**TOWN OF MOUNTAIN VILLAGE  
REGULAR DESIGN REVIEW BOARD MEETING  
AGENDA**

**THURSDAY MAY 6, 2021 10:00 AM**

**TO:** Mountain Village Design Review Board  
**FROM:** John Miller, Senior Planner  
**FOR:** Design Review Board Public Hearing; May 6, 2021  
**DATE:** April 26, 2021  
**RE:** Staff Memo – Final Architecture Review Lot 161D-1 Unit 19

SHEET No.  
**A1.7**  
SCALE: AS SHOWN

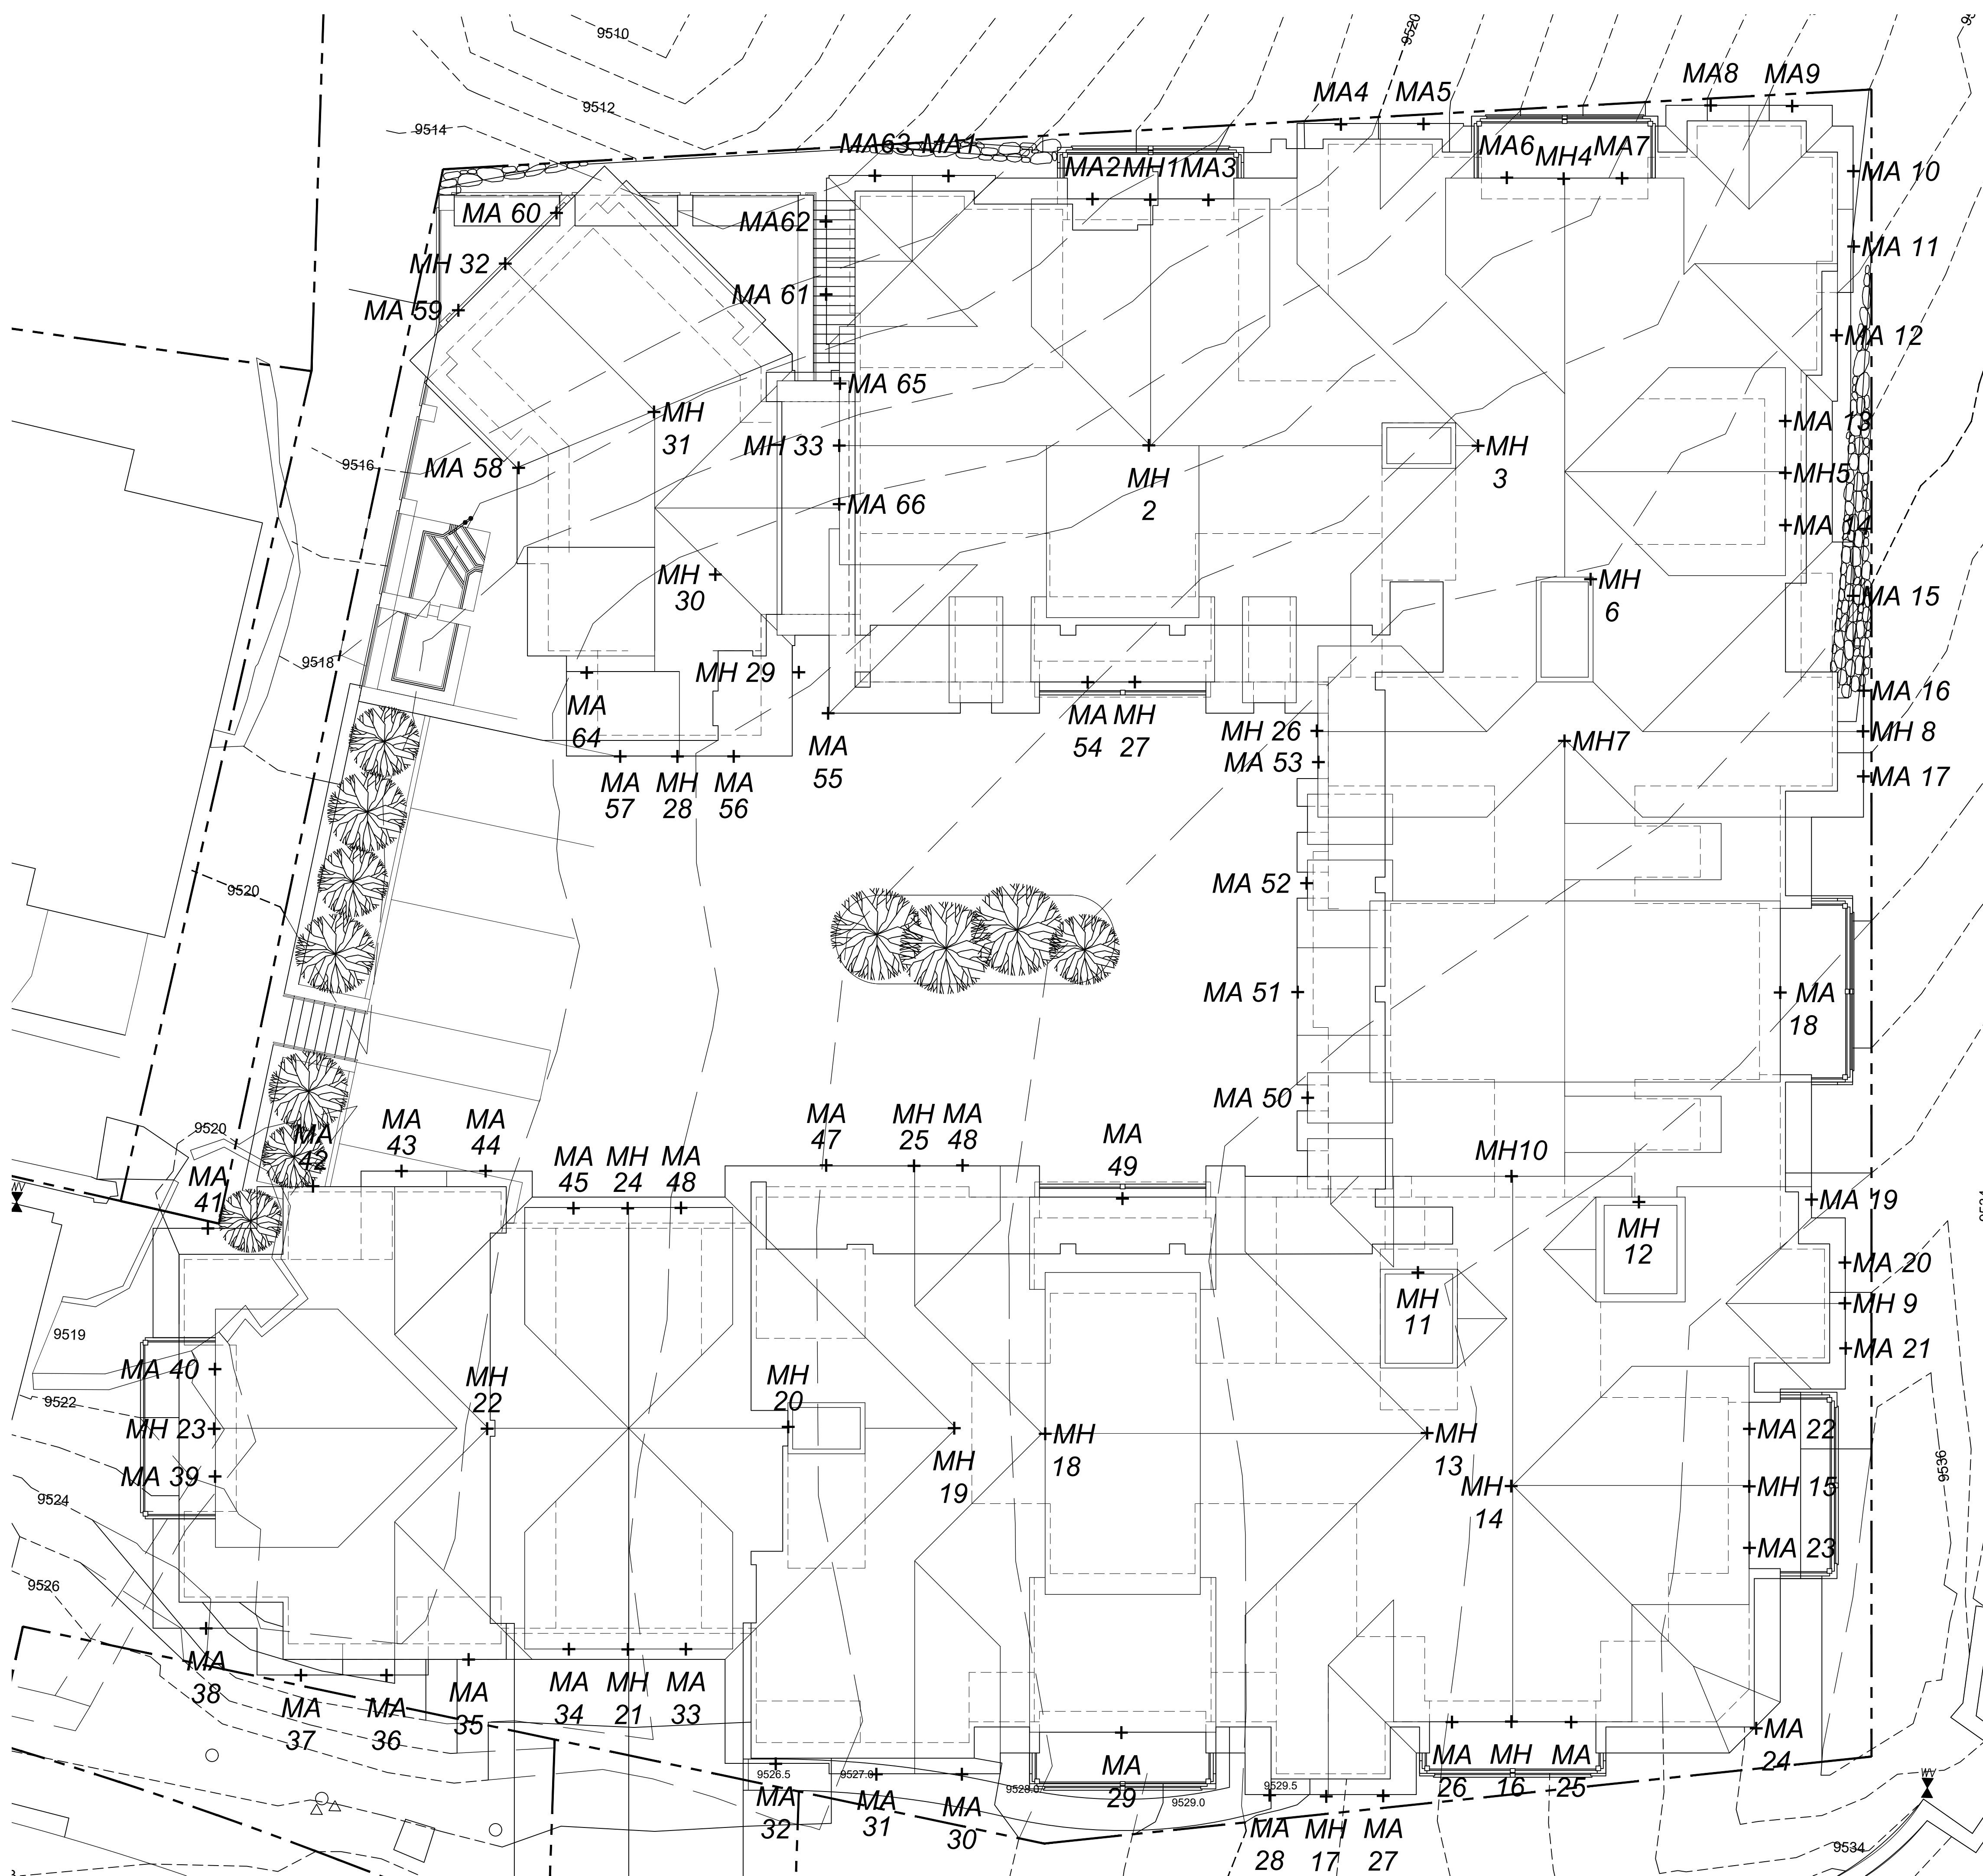
*Staff: The Maximum Building Height and Average Building Height analysis has been provided on pages A1.7 and A1.8 of the submitted plan set and shown above in Table 1. With a Maximum Height of 52.9 feet and a Max Average Height of 39.4 feet, the proposed complies with the CDC requirements for building height. The applicant has also provided a parallel plane analysis in accordance with CDC requirements. It should be noted that any approval should condition a height survey to be required prior to the issuance of a framing inspection to verify that the heights comply with any DRB approved plan.*
